### THM 4L60-E NEW DESIGN VALVE BODY AND SPACER PLATE FOR 2001

03-16 Page 1 of 4

### CONVERTER CLUTCH REGULATOR VALVE LINE-UP

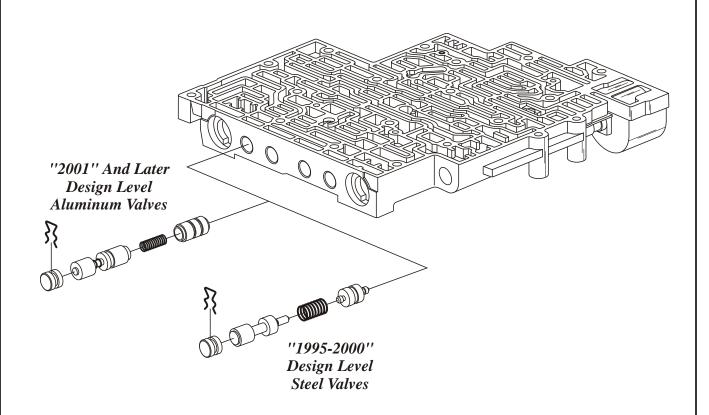
**CHANGE:** Beginning at the start of production for 2001, all 4L60-E transmissions were produced with a new design converter clutch regulator valve line-up located in the valve body, in the location shown in Figure 1.

- (1) TCC REGULATOR AND ISOLATOR VALVES This line-up now has re-designed aluminum TCC Regulator Valve and Isolator Valves, instead of the previous steel, as shown in Figure 1.
- (2) VALVE BODY CASTING Has changed in the worm track areas that are identified inside the circles, as shown in Figure 2, to accommodate the new design converter clutch regulator and isolator valves.
- (3) SPACER PLATE There are two holes in the spacer plate that have been revised, as shown in Figure 3, to accommodate the new design converter clutch regulator and isolator valves.
